4/14/2015

RE: Delta Shores Regional Commercial Center

Figure 1: Planned Unit Development Guidelines (2008)

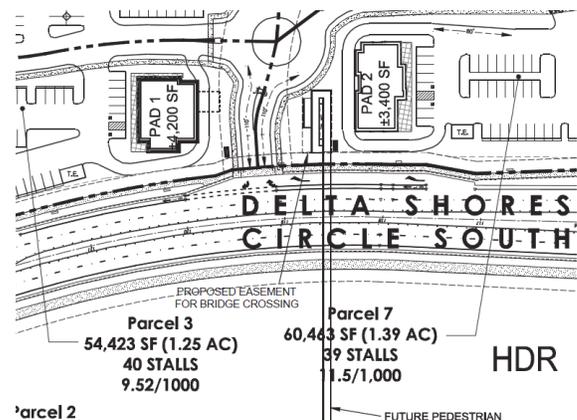
The 2008 Delta Shores Planned Unit Development Guidelines included a conceptual plan for a pedestrian bridge providing a connection across the commercial loop roadway between the Village Center and the high-density residential uses on the east side. The pedestrian bridge would assure pedestrians and bicyclists a safe and convenient route to pedestrian-oriented entertainment and small-scale commercial uses in the Village Center portion of the regional commercial center. Figure 1 shows the Town Center at the top and the high-density residential at the bottom with the bridge between them as approved in 2008.
